SAFETY EVALUATION REPORT
ON PROPOSED REMEDIATION OF THE CHEMETRON
FACILITIES AT THE BERT AVENUE SITE
IN NEWBURGH HEIGHTS, OHIO

LICENSE NUMBER SUB-1357
DOCKET NUMBER 040-08724

CHEMETRON CORPORATION

February 12, 1997

Figure 4.1 Assumed truck shipment route from Cleveland, OH, to Clive, UT.

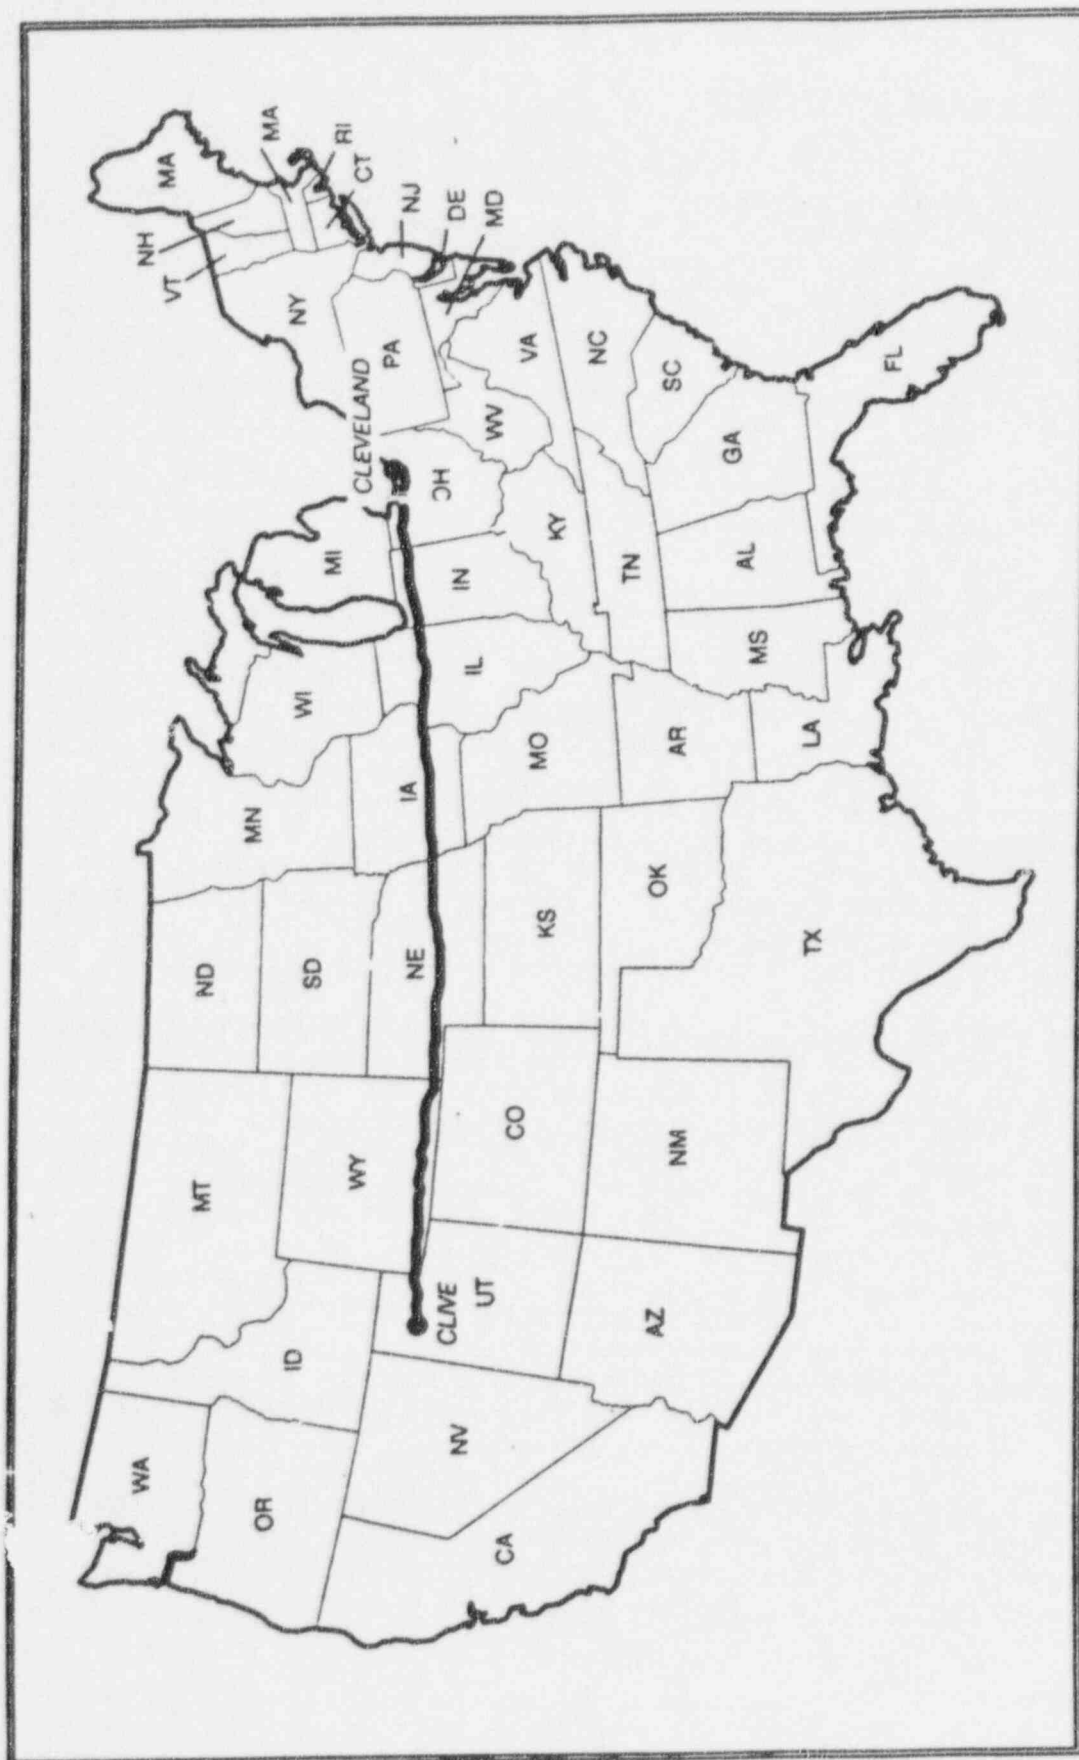
For truck shipments, it was assumed that the route depicted on Figure 4.1 would be used from Cleveland, Ohio, to Clive, Utah. This route is 2860-km (1775-miles) long and, at an average speed of 80 km/hr (50 mile/hr), the trip duration would be 36 hr. For rail shipments a route length of 2860-km (1775-miles) long was also assumed, and, at an average speed of 64 km/hr (40 mile/hr), the trip duration would be 45 hr.

Staff performed calculations using the MICROSIELD code (Reference 24) to determine exposure rates at the sides of trucks or railcars having 0.32-cm (0.125-in) steel sides, containing wastes at a concentration of 529 Bq/gm (14,300 pCi/gm) total uranium, the maximum concentration found in Chemetron's waste characterization program. The exposure rate in the truck cab, 61 cm (2 ft) from the end of the truck, would be 1.47E-3 mSv/hr (0.147 mrem/hr) above background. The exposure rate 2.0 m (6.6 ft) from the side of the truck would be 2.1E-4 mSv/hr (0.021 mrem/hr) above background. At these exposure rates the truck driver would receive a dose of less than 0.0588 mSv (5.88 mrem) per trip. The total exposure for the 28 trips would be 1.65 person-mSv (165 person-mrem). The exposures to truck drivers would be substantially less than NRC and DOT limits of 0.02 mSv/hr (2 mrem/hr) in occupiable spaces within the truck cab and 0.1 mSv/hr (10 mrem/hr) at 1.8 m (6 ft) from any side of the truck.

Because of the near-background exposure rates, individuals traveling along the highway adjacent to the trucks or residing near the highway would receive negligible exposures from these shipments. Background exposure rates are generally about 2.6 pC/kg (10 µR/hr) to 3.9 pC/kg (15 µR/hr).
